SUBJECT: ISSUANCE OF AMENDMENT NO. 8 TO FACILITY OPERATING LICENSE NO.
NPF-86 - SEABROOK STATION, UNIT NO. 1 (TAC NO. 81146)

AMENDMENT NO. 8 TO NPF-86 SEABROOK STATION DATED November 18, 1991

Amendment No. 8
License No. NPF-86

SAFETY EVALUATION BY THE OFFICE OF NUCLEAR REACTOR REGULATION
SUPPORTING AMENDMENT NO. 8 TO FACILITY OPERATING LICENSE NO. NPF-86

FIGURE 3.1-1

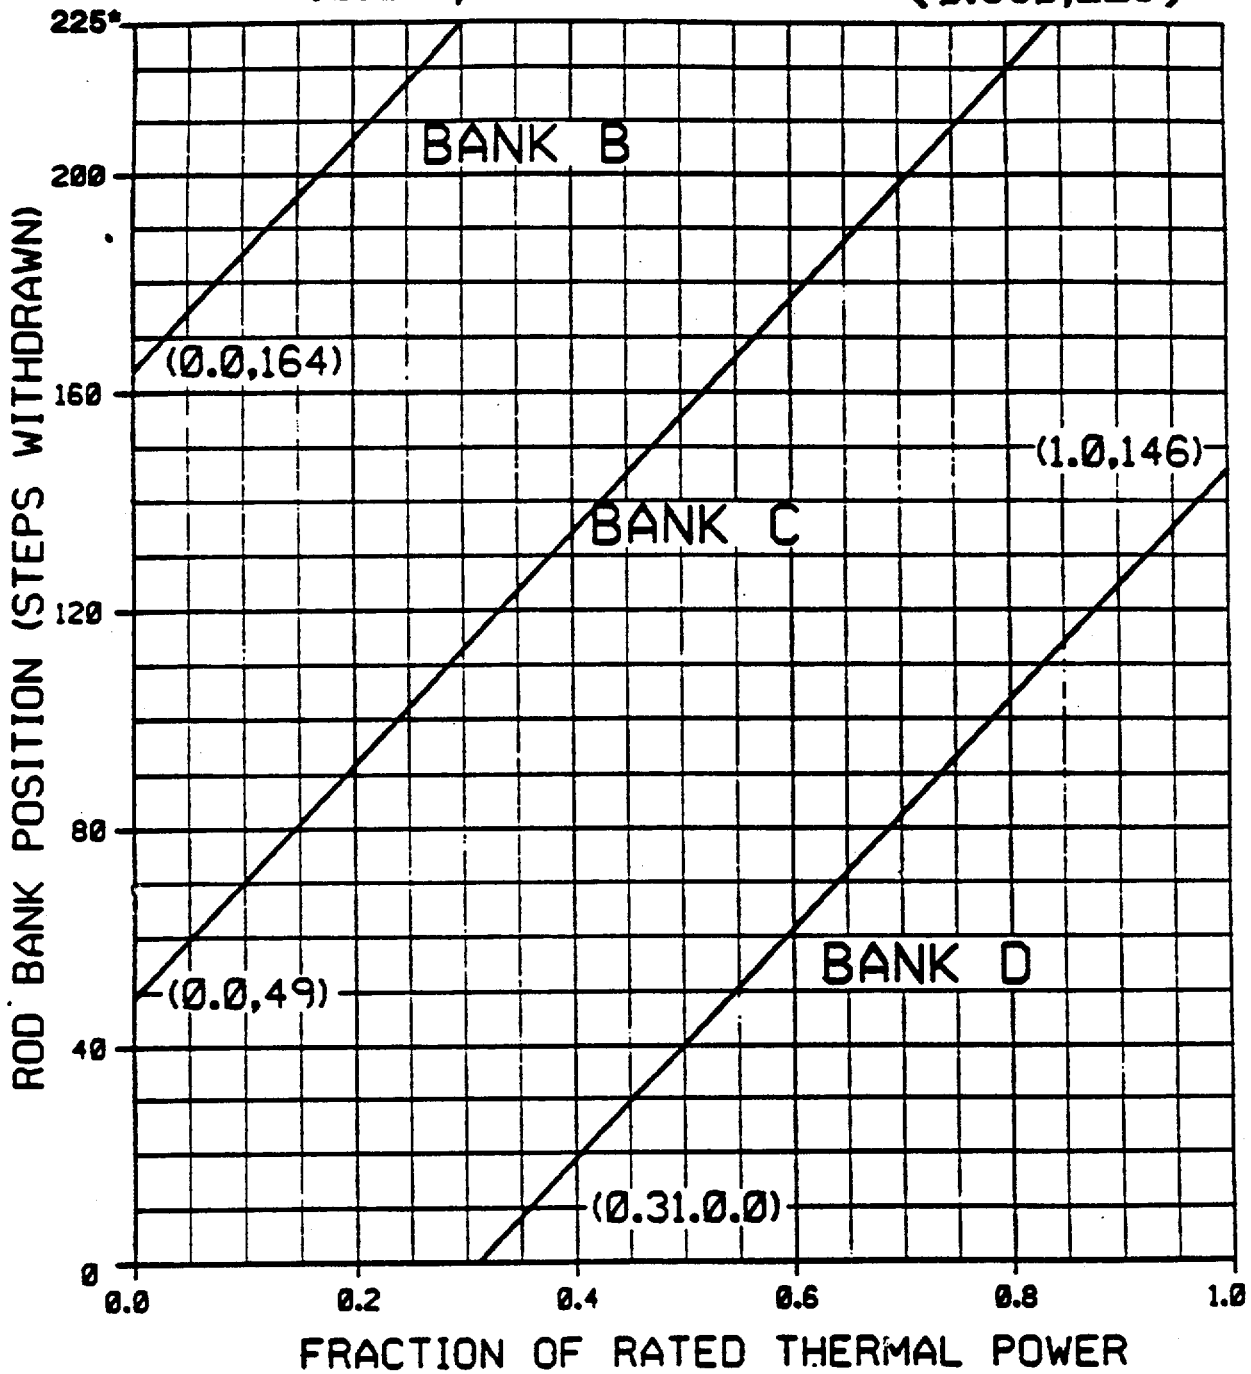
BANK A MUST BE FULLY WITHDRAWN* PRIOR TO POWER OPERATION

* Fully Withdrawn = 225 to the mechanical fully withdrawn position, inclusive
